# Access Compliance Report

## Public Rights-of-Way

### (Curb Ramps)

Intersection ID: 13891	Main Street: CLEMENT_AV	Cross Street: E_7TH_ST	Location: W
ADA ID: 6D6C10BFDBDE	Ramp Type: Directional1	Initial Pass/Fail: Fail	Overall Compliance: No
Severity Score: 1.25			
Codes/Mitigation Info/Possible Solution		Field Measurements/Component Compliance

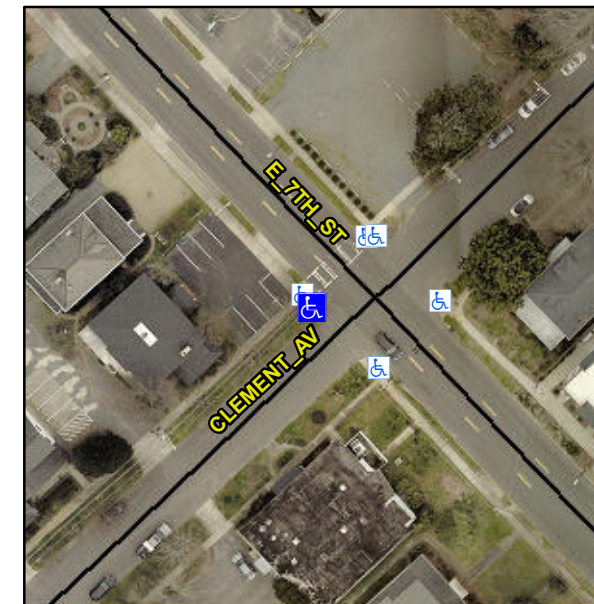
**R304.5.3**

Compliance	Description	Data	Compliance	Description	Data
N/A	Ramp Length (in)	86.0	N/A	Grade Break?	N/A
Yes	Ramp Width (in)	72.0	N/A	Grade Break Slope (%)	0.0
Yes	Ramp Slope (%)	0.5	N/A	Grade Break XSlope (%)	0.0
No	Ramp XSlope (%)	3.1			
N/A	Flare Type LT	N/A	N/A	Flare Type RT	N/A
N/A	Flare Slope LT (%)	N/A	N/A	Flare Slope RT (%)	0.0
N/A	Flare Traversable LT?	N/A	N/A	Flare Traversable RT?	N/A
N/A	Landing Length (in)	0.0	N/A	DWS Provided?	N/A
N/A	Landing Width (in)	0.0	N/A	DWS Contrast?	N/A
N/A	Landing Slope (%)	0.0	N/A	DWS Length (in)	N/A
N/A	Landing X Slope (%)	0.0	N/A	DWS Full Width?	N/A
N/A	Landing Curb? (Y/N)	N/A	N/A	DWS Offset LT (in)	N/A
N/A	Shared Landing?	N/A	N/A	DWS Offset RT (in)	N/A
N/A	Gutter Ponding?	0.0	N/A	Gutter Slope (%)	N/A
N/A	Gutter Lip Ht (in)	0.0	N/A	Gutter X Slope (%)	N/A
N/A	Painted X Walk1?	No		Road Slope (%)	3.1
	X Walk 1 Direction	To SE		Road X Slope (%)	0.4
	X Walk 1 Width (in)	N/A		Clear Space?	N/A

**Remove & Replace Entire Ramp.**
